Planning Application Response

Local Authority:	Chesterfield Borough Council
Detail:	Residential development of 31 affordable dwellings with associated access, parking and landscaping. Land to the east of Lodge Close Brimington Chesterfield S43 1PB
Planning Ref:	CHE/19/00771/FUL
Closing Date:	25 th January 2020

Response to:	Planning@Chesterfield.gov.uk
Submitted by	Mandy Loach – Trans Pennine Trail Officer
Date:	16 th January 2020
Summary	<p>This application covers the development of 31 affordable dwellings to the east of Lodge Close, Brimington.</p> <p>This development is adjacent to the Trans Pennine Trail but is not referenced anywhere within the documentation.</p> <p>The Trans Pennine Trail cannot support this development until the recommended changes in the Design & Access statement and Transport Statement are addressed and the national Trans Pennine Trail recognised throughout the application as a directly connecting sustainable transport route.</p>
Detailed Information:	The map below indicates the alignment of the Trans Pennine Trail in relation to the proposed development site. At this point the Trail is multi-use for walkers, cyclists and horse riders:

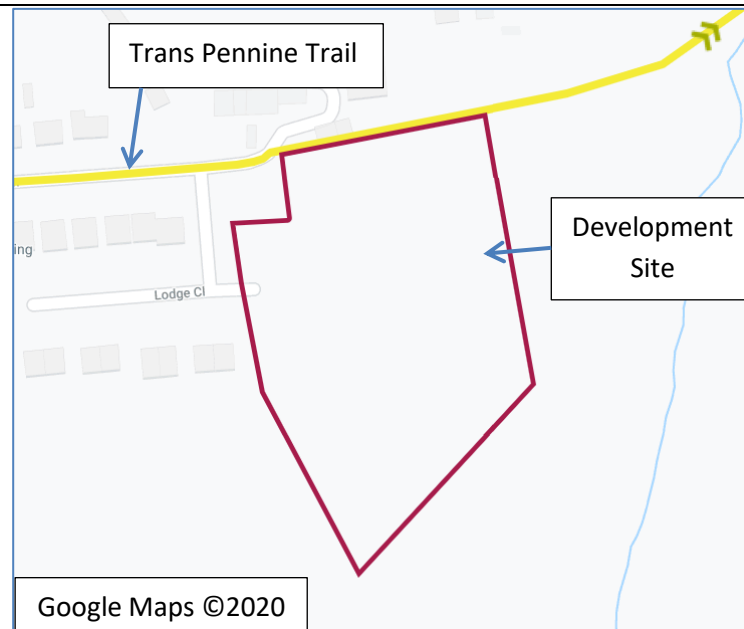
As evidenced on the above plan, the national Trans Pennine Trail runs adjacent to the north of the proposed development site but is not highlighted as a major sustainable transport route within the application. At this location the Trail is full multi-use (walkers, cyclists and horse riders).
